**PUBLIC SERVICE COMMISSION OF WISCONSIN**

In the Matter of the Proposed Revision of Wis. Admin. Code ch. PSC 114 as 1-AC-250 Wisconsin State Electrical Code, Volume I

Clearinghouse Rule No. 18-007

**ORDER ADOPTING FINAL RULE**

Figure PSC 114-317B1.

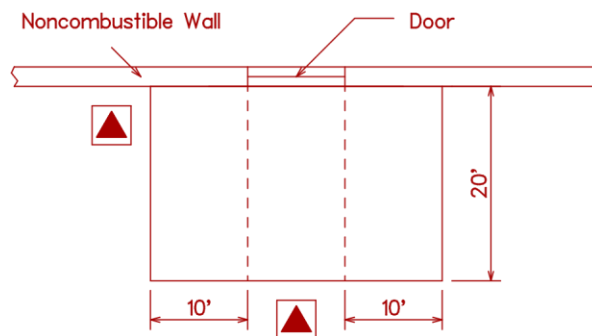
1. Padmounted oil-insulated transformers shall not be located within a zone extending 6.1 m (20 ft) outward and 3.0 m (10 ft) to either side of a building door. See Figure PSC 114-317B1.

Figure PSC 114-317B2.

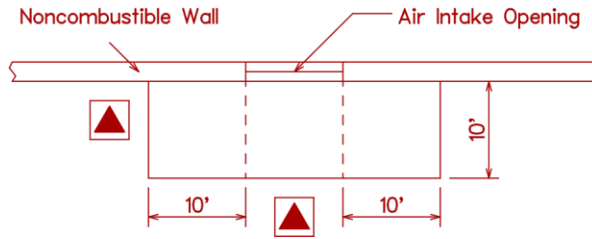
2. Padmounted oil-insulated transformers shall not be located within a zone extending 3.0 m (10 ft) outward and 3.0 m (10 ft) to either side of an air intake opening. Such transformers may be located within said zone beneath an air intake opening provided there is not less than 7.6 m (25 ft) diagonal separation between the transformer and said opening. See Figure PSC 114-317B2.

Figure PSC 114-317B3a.

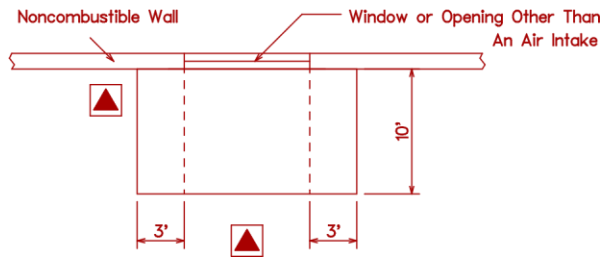
3.a. Padmounted oil-insulated transformers shall not be located within a zone extending 3.0 m (10 ft) outward and 0.9 m (3 ft) to either side of a building window or opening other than an air intake. See Figure PSC 114-317B3a.

Exception: This does not apply to a glass block or fire window meeting the requirements of the Wisconsin Commercial Building Code (Fire Window IBC Chapter 7, Section 714.3).

Figure PSC 114-317 B3b.

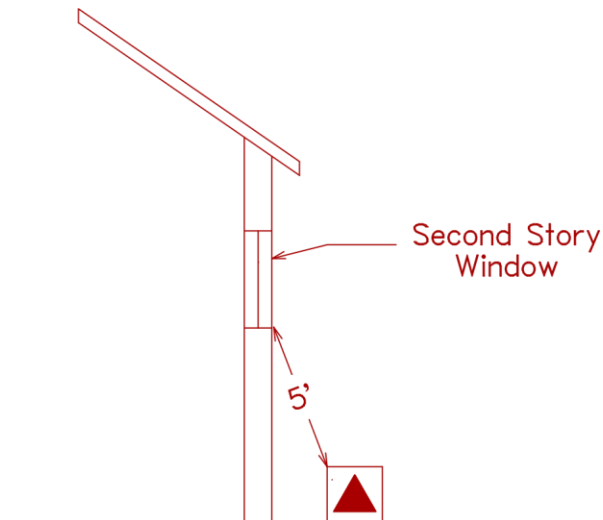
3.b. For second story windows, the transformer shall not be located less than 1.5 m (5 ft) from any part of the window. See Figure PSC 317B3b.

Exception: This does not apply to a glass block or fire window meeting the requirements of the Wisconsin Commercial Building Code (Fire Window, IBC Chapter 7, Section 714.3).

Figure PSC 114-317D1.

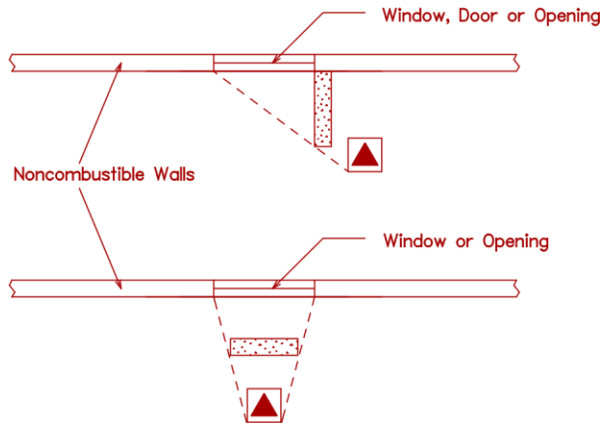
The barrier shall extend to a projection line from the corner of the padmounted transformer to the furthest corner of the window, door or opening in question. The height of the barrier shall be 0.3 m (1 ft) above the top of the padmounted transformer. See Figure PSC 114-317D1.

Figure PSC 114-317D2.

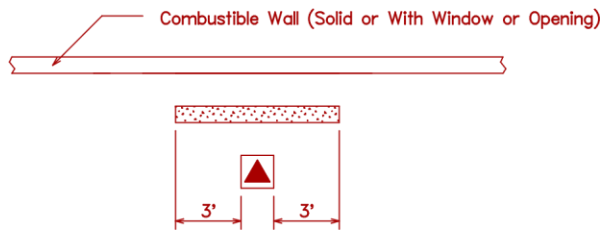
The barrier shall extend 0.9 m (3 ft) beyond each side of the padmounted transformer. The height of the barrier shall be 0.3 m (1 ft) above the top of the transformer. See Figure PSC 114-317D2.

Figure PSC 114-317E1

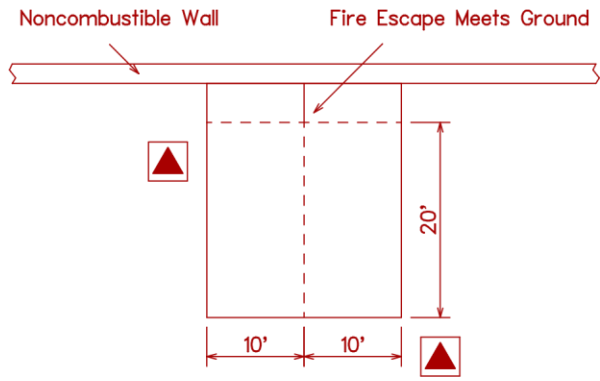
1. Padmounted oil-insulated transformers shall not be located within a zone extending 6.1 m (20 ft) outward and 3 m (10 ft) to either side of the point where a fire escape meets the ground. See Figure PSC 114-317E1.
2. Padmounted oil-insulated transformers located beneath fire escapes shall have a vertical clearance of not less than 3 m (10 ft) from the top of the transformer to the bottom of the fire escape. See Figure PSC 114-317E2.
